ASSESSMENT REPORT

Nadine Street Residential Subdivision, Sanctuary Point DA 485-12-2002 MOD 1

Figure 4: Proposed residential lot layout (Base source: Proponent's application)

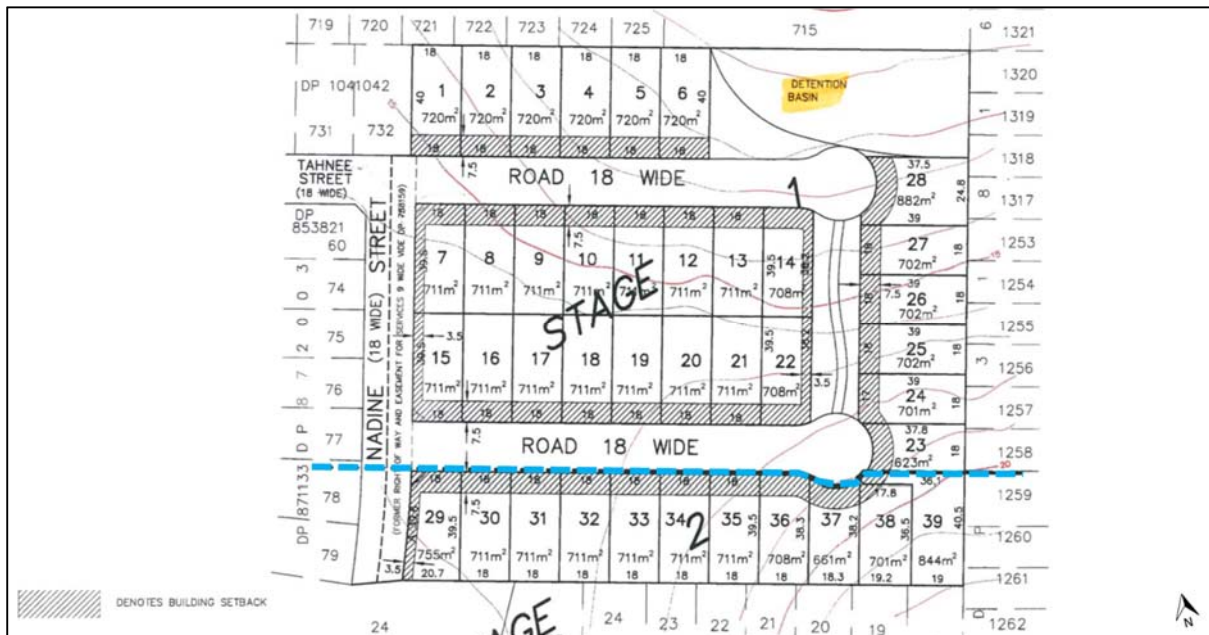
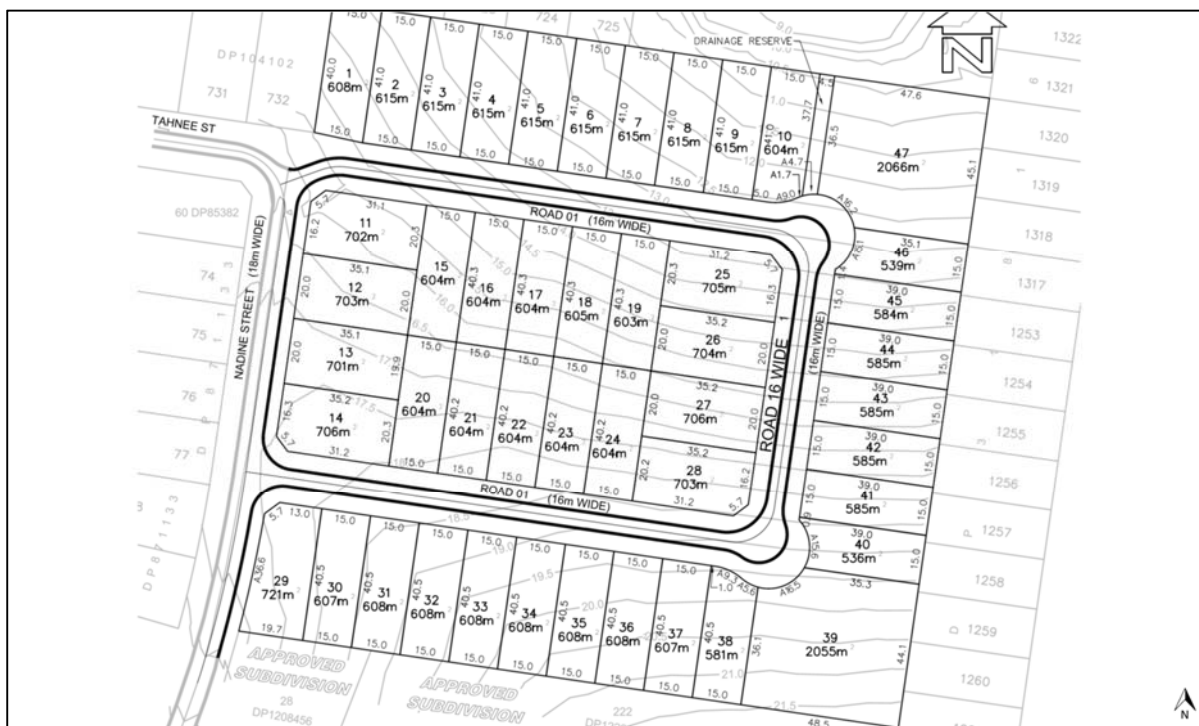
Issue	Consideration	Recommendation
<i>East-west oriented lots</i>	- The original DA allowed for the creation of residential lots with a minimum width of 18 m. The proposal seeks to reduce the minimum lot width by 3 m, to 15 m (Figures 3 and 4). - Public submissions raised concern that the lots are too narrow and may result in privacy impacts if two-storey dwellings are erected. - Council raised concern that the east-west oriented lots, located along the eastern boundary of the subdivision are too narrow and, may result in privacy and overshadowing impacts and should be increased to a minimum width of 16 m in accordance with SDCP 2014. - The Proponent argues the proposed 15 m wide residential lots are acceptable, as: - lots with 15 m widths are not uncommon within the Shoalhaven LGA and Council has recently approved 15 m wide residential lots in other locations; and - the east-west lots slope north and therefore can accommodate single and two-storey dwellings without adverse overshadowing impacts. - The Department notes SDCP 2014 stipulates rectangular lots should not be narrower than 16 m and allow for a 15 m x 15 m building envelope. - With regard to the north-south oriented lots, the Department considers that despite the SDCP 2014 provisions, a 15 m lot width is acceptable as these lots would gain good levels of solar access and can be designed to minimise privacy impacts. The Department also notes Council raised no concern with the width of these lots. - The Department agrees with Council that the east-west orientated lots should be increased in width by 1 m to comply with SDCP 2014 minimum (16 m) to ensure future dwellings achieve appropriate levels of amenity, in terms of solar access and privacy. - The Department notes this increase could reasonably be accommodated by a minor reduction in the width of the large corner lots. The Department recommends a condition accordingly.	The Department has recommended a new condition B10 (a) requiring the east-west oriented lots be increased to 16 m in width.

<i>Culs-de-sac</i>	- Conditions B2(b), B2(c) and B2(l) require the provision of northern and southern cul-de-sac and an accessible north/south concrete pavement connecting the cul-de-sac (refer to Figure 3). - The proposal seeks to delete Conditions B2(b) B2(c) and amend Condition B2(l) because a loop road is now proposed to replace the two culs-de-sac and connecting concrete pavement. - The Department is satisfied Condition B2(c) is no longer necessary, given the revised subdivision design. In addition, the proposed loop road is considered to provide a superior layout when compared with the approved layout comprising two culs-de-sac.	The Department has recommended Conditions requiring B2(b), B2(c) be deleted, and Condition B2(l) be modified as requested.
<i>Staging</i>	- Condition A3 requires the development to be delivered in two stages. - The proponent seeks to delete Condition (A3) as it no longer proposes to stage the development. - The Department considers a single stage development is appropriate, as it is likely to: - reduce the duration of construction/site preparation works; - provide for a more efficient construction program; and - reduce potential construction impacts on neighbouring residential properties.	The Department has recommended Condition A3 be deleted as requested.
